ADP G121EAN01.001 EC Notice

EC Notice of Cell FAB Change to G5

* Purpose: In order to increase production capacity allocation, need to verify another cell Fab for better allocation.

One Page Spec

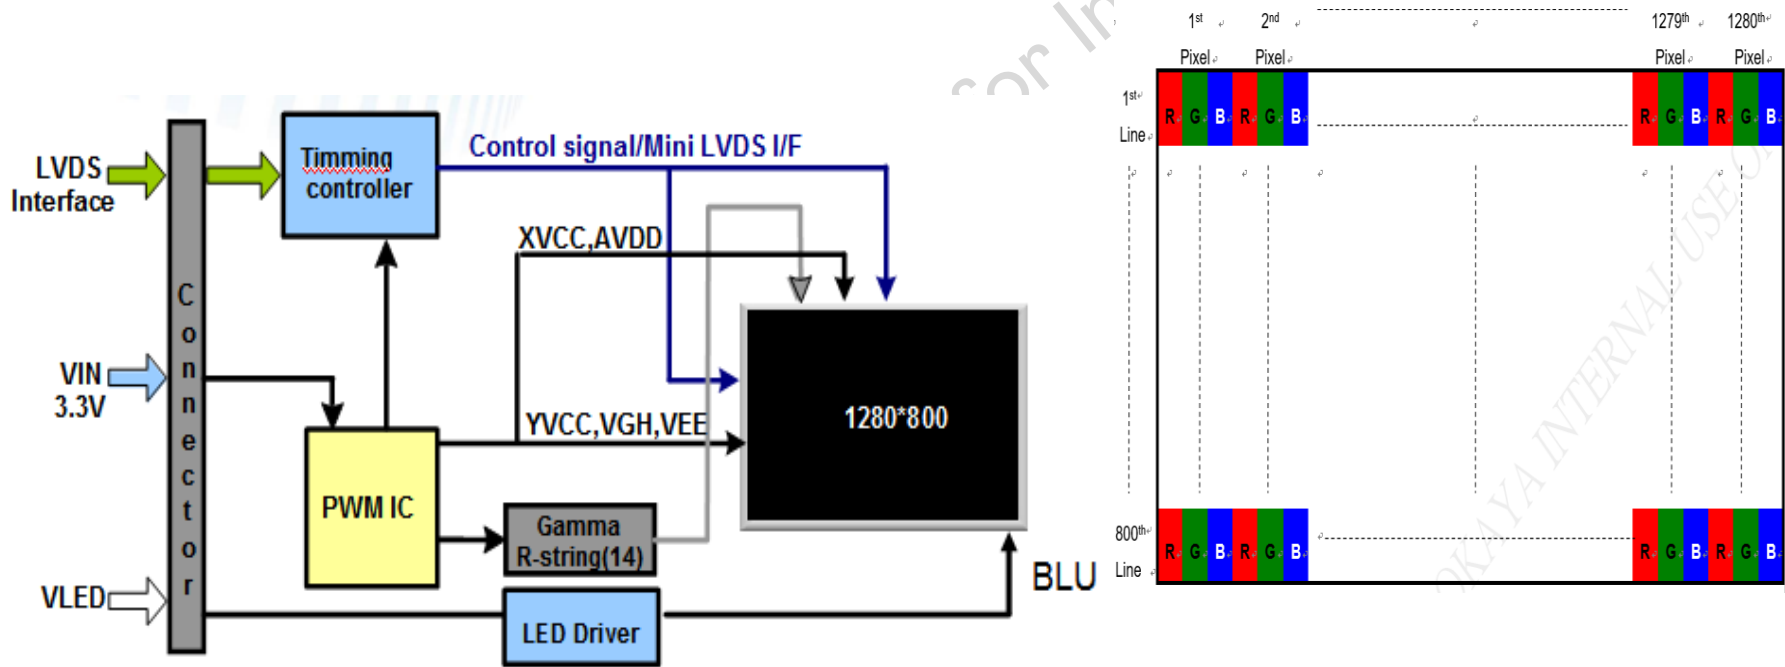
G121EAN01.001 has the comparable/ key specs as G121EAN01.000, only cell FAB change to G5.

(Preliminary) Spec.	G121EAN01.000 (Before EC)	G121EAN01.001 (After EC)
Outline Dimensions (mm)	278.0 x 184.0	←
Thickness (mm)	9.29	←
Active Area (mm)	261.12(H)×163.2(V)	←
Resolution (Pixel)	1280 RGB(H)×800(V)	←
Display Mode	AHVA	←
Contrast Ratio	800:1 (Min.)	←
Brightness	500(Typ.)	←
Response Time (typ.)	25 ms	←
Viewing Angle_ CR>10 (typ., H/ V)	89 / 89 / 89 / 89	←
LED Life Time	70K	←
Weight	480g	←
Interface	LVDS	←
Support Color	16.2M (8bit) / 262K (6bit)	←
Color Gamut (typ.)	72%	←
W(x, y) (typ.)	(0.313 , 0.329)	←
Power Consumption	6.06W	←
Power Supply Voltage (typ.)	12V	←
Operation Temp. (°C)	-30 ~ 85 °C	←
Storage Temp. (°C)	-30 ~ 85 °C	←
Remark	---	New PCBA due to gate IC quantity is changing from 2pcs to 1pcs after EC.

Mechanical Front / Rear - View

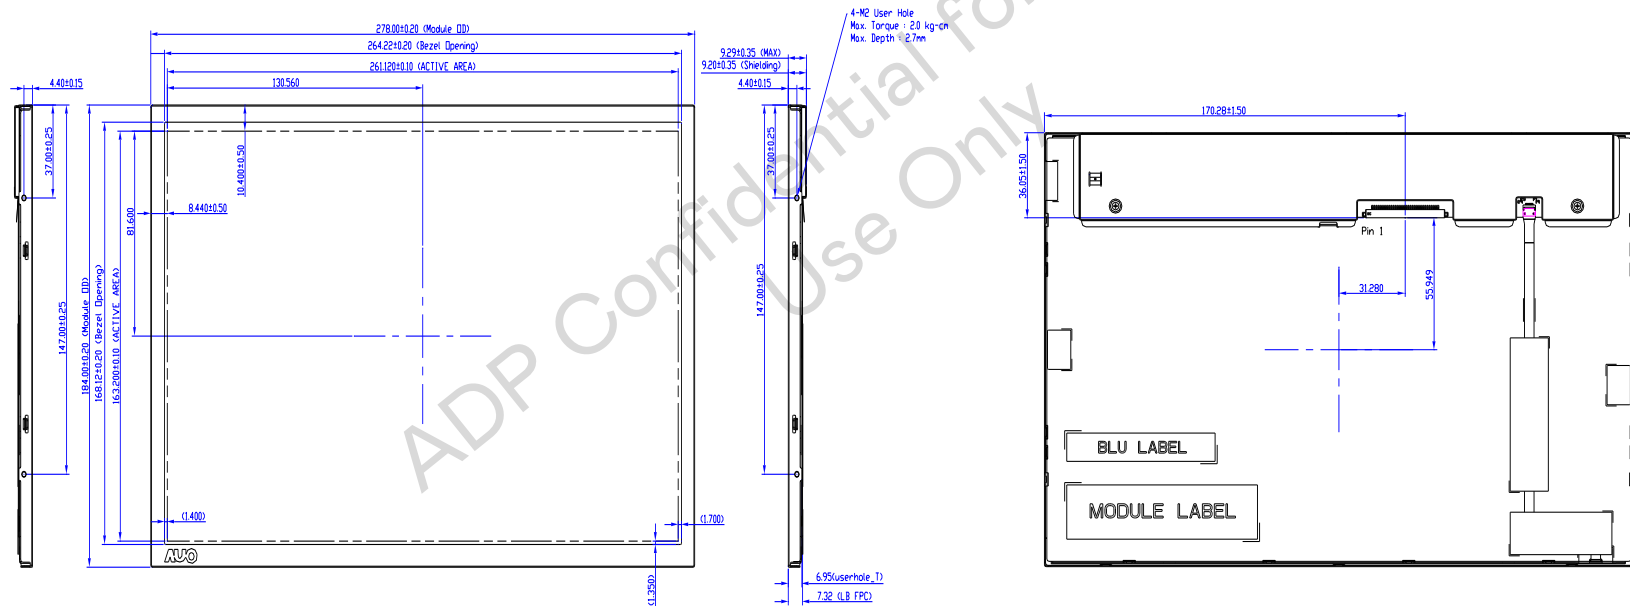
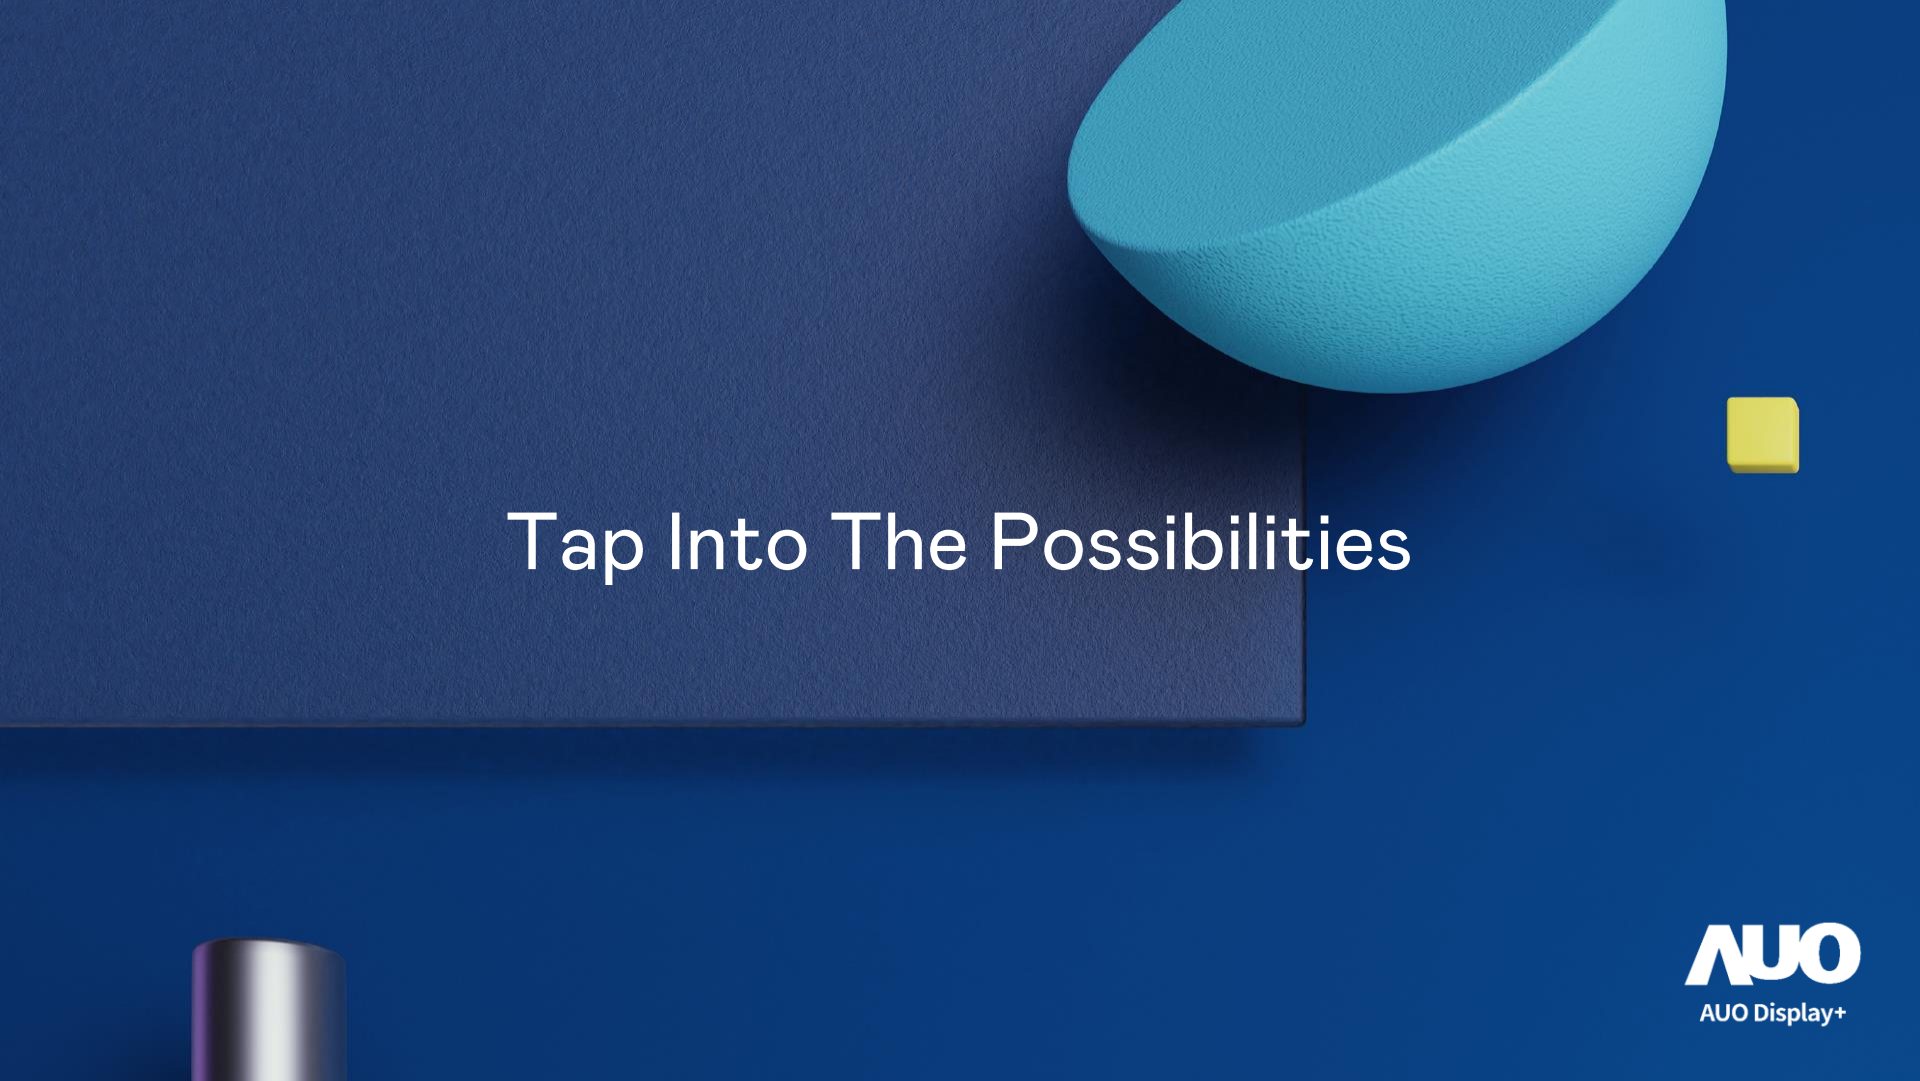
G121EAN01.001 mechanical is comparable as G121EAN01.000

G121EAN01.001 has the same mounting hole design as G121EAN01.000
